**Planning Commission - Subdivision Review Committee  
City and Borough of Juneau  
Paul Voelckers, Chairman**

July 14, 2015

Subdivision Review Committee Meeting - Tuesday May 19<sup>th</sup> 2015

**MEMORANDUM**

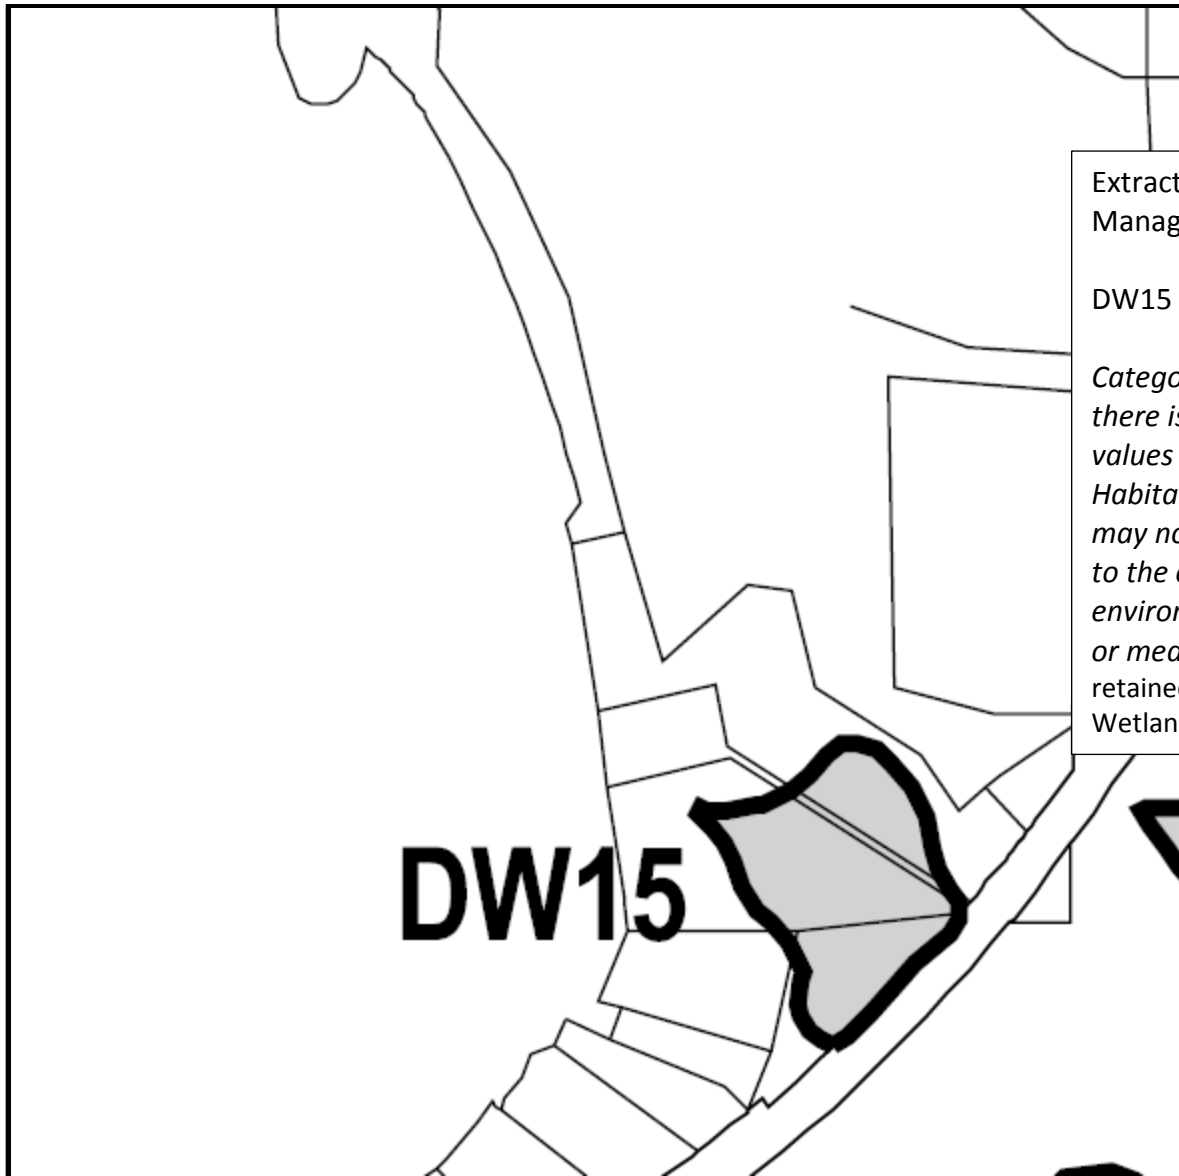
All proposed lots would provide a minimum 150-foot square within the lot boundaries. The Realtor has indicated that in the long term, the a road would be required to develop the large remainder parcel to the north because of the ratio of available land to available road frontage. However, at present, the owners preference would be for approval for the new lot along the southerly border without the expense of improving the current driveway i.e. they would wish for Proposal 1. Fire regulations may require some upgrade of this driveway.

The Realtor has suggested that the extensive wetlands in the area at southeast corner of Lot A would likely be too expensive to sensibly develop that lot shown on Proposal 2. The owners are not overly concerned about losing the opportunity to create this additional lot. Staff also advises against creating a lot that is exclusively wetlands.

- **150ft of road frontage** would be required for lots in Rural Reserve (measured at the 25ft setback) for no variance or Director's discretion to be required.

- All lots are required to have **30ft of road frontage** or a variance is required.
- **Variances and easements** may be required depending on the number of lots being created as this affects the location of driveways and any lot width.

- **Existing Wetlands** (see attached Wetlands Map) could make it difficult to construct on parts of the current Lot A. Understanding the scale of this cost and wetland management implications would aid a decision as to whether the Director's discretion is applied or provide a supporting case for a variance. Staff recommends that not lots are created that are entirely wetlands. A wetlands delineation may be required to determine the actual location and extent of any wetlands.

- The **driveway configuration** for both proposals should be described. Access to all lots via one driveway or Right Of Way on to N. Douglas Hwy is probably required by DOT. In both proposals access driveways may require fill permits unless the access proposal in the VAR20090019 is implemented.

**RE:** Two lot subdivision of 9227 Long Run Drive

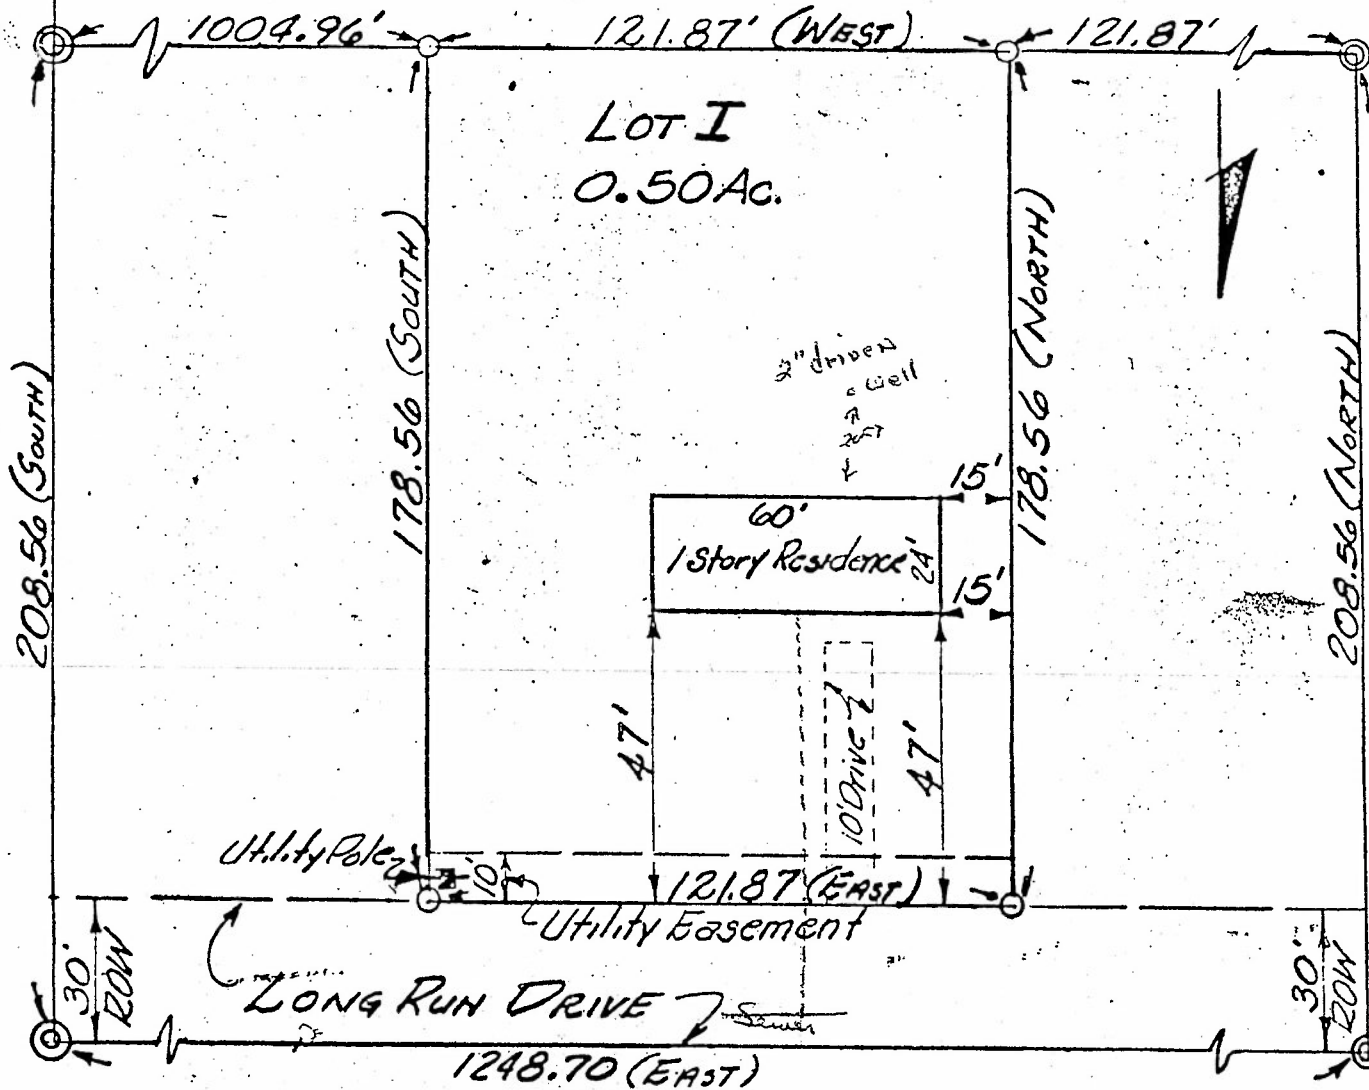
The property owner would like to subdivide the property located at 9227 Long Run Drive. The lot is in the D-5 zoning district and is 21,780 square feet. The current structure sits 46.26 feet from the front lot line, 17.48 feet from the western lot line and approximately 19 feet from the eastern property line. The minimum side yard setback in the D-5 zoning district is 5 feet.

According to CBJ 49.15.460(5) all lots must have at least 30 feet of frontage on a dedicated right-of-way. The lot could be subdivided into a standard D-5 lot and bungalow lot. However, the house would have to be rotated 90 degrees to the north. The lot also qualifies for the minimum rectangle provision found in CBJ 49.15.460(4)(A)(i). In order to create this subdivision the house would still need to be rotated.

The property owner has stated moving the current structure is too cost prohibitive and would like to apply for a Variance to the 30 foot road frontage requirement in order to apply the minimum rectangle provision.
